Access Compliance Report

Public Rights-of-Way

Main Street: DALE_ST Cross Street: ORANGEWOOD_AVE Location: SE

ADA ID: SGRK210928110633 Signal Type: One Push Button-Non APS Overall Compliance: No Severity Scores: BTN 1: 35 BTN 2: N/A No BTN: N/A

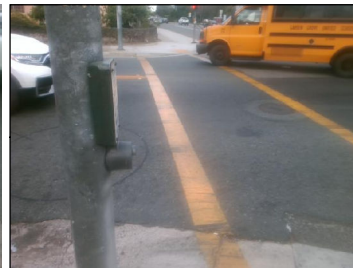
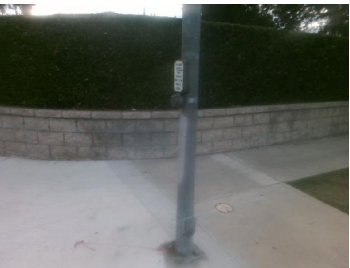
Compliance	Description	Data	Compliance	Description	Data
Button Count	Button1	Yes	Distant to Additional Button (in)	224	
Additional Button Present?	Yes	N/A	Additional Button ID	SGRK21092811002	
Located In An Island/Median?	No				
N/A B 1 Sign Present?	Yes	N/A	B 2 Sign Present?	N/A	
Yes B 1 Sign Purpose?	Yes	N/A	B 2 Sign Purpose?	N/A	
Yes B 1 Sign Lettering & Contrast?	Yes	N/A	B 2 Sign Lettering & Contrast?	N/A	
Yes B 1 Parallel To XWalk?	Yes	N/A	B 2 Parallel To XWalk?	N/A	
N/A B 1 PAR to Button?	N/A	N/A	B 2 PAR to Button?	N/A	
N/A B 1 PAR to XWalk?	N/A	N/A	B 2 PAR to XWalk?	N/A	
Yes B 1 Clear Floor Space?	Yes	N/A	B 2 Clear Floor Space?	N/A	
N/A B 1 FWD Approach?	N/A	N/A	B 2 FWD Approach?	N/A	
N/A B 1 FWD Approach Constrained?	N/A	N/A	B 2 FWD Approach Constrained?	N/A	
N/A B 1 FWD Approach Reach (in)	N/A	N/A	B 2 FWD Approach Reach (in)	N/A	
N/A B 1 FWD Approach Width (in)	N/A	N/A	B 2 FWD Approach Width (in)	N/A

N/A B 1 FWD Approach Obstruction?	N/A	N/A	B 2 FWD Approach Obstruction?	N/A	
N/A B 1 FWD Approach Obstruction Dist (in)	N/A	N/A	B 2 FWD Approach ObstructionDist (in)	N/A	
N/A B 1 PARA Approach?	N/A	N/A	B 2 PARA Approach?	N/A	
N/A B 1 PARA Approach Constrained?	No	N/A	B 2 PARA Approach Constrained?	N/A	
Yes B 1 PARA Approach Reach (in)	0	N/A	B 2 PARA Approach Reach (in)	N/A	
N/A B 1 PARA Approach Width (in)	N/A	N/A	B 2 PARA Approach Width (in)	N/A	
N/A B 1 PARA Approach Obstruction?	No	N/A	B 2 PARA Approach Obstruction?	N/A	
N/A B 1 PARA Approach Obstruction Dist (in)	N/A	N/A	B 2 PARA Approach Obstruction Dist (in)	N/A	
Yes B 1 Clear Floor Space Slope (%)	0.1	N/A	B 2 Clear Floor Space Slope (%)	N/A	
No B 1 Clear Floor Space XSlope (%)	3.7	N/A	B 2 Clear Floor Space XSlope (%)	N/A	
N/A B 1 PAR Slope (%)	4.3	N/A	B 2 PAR Slope (%)	N/A	
Yes B 1 Height (in)	47	N/A	B 2 Height (in)	N/A	
Yes B 1 Pressure (#)	5	N/A	B 2 Pressure (#)	N/A

No B 1 Closed Fist Operation?	No	N/A	B 2 Closed Fist Operation?	N/A	
No B 1 Diameter (in)	0.25	N/A	B 2 Diameter (in)	N/A	
N/A B 1 Crossing Direction	W	N/A	B 2 Crossing Direction	N/A	
Yes B 1 DistanceTo XWalk (in)	35	N/A	B 2 DistanceTo XWalk (in)	N/A	
Yes B 1 DistanceTo Curb (in)	23	N/A	B 2 DistanceTo Curb (in)	N/A	
Parcel Identification Number	132-252-20				
Google Street View Link					
http://www.google.com/maps/@?api=1&map_action=pano&viewpoint=33.79560827,-117.984132

Possible Solutions: Replace Signal Push Button With APS Button. Remove and Replace Clear Space.

OC Std/PROW: R404.2, DMS-11132, R104.2, R209.1, MUTCD 4e.08
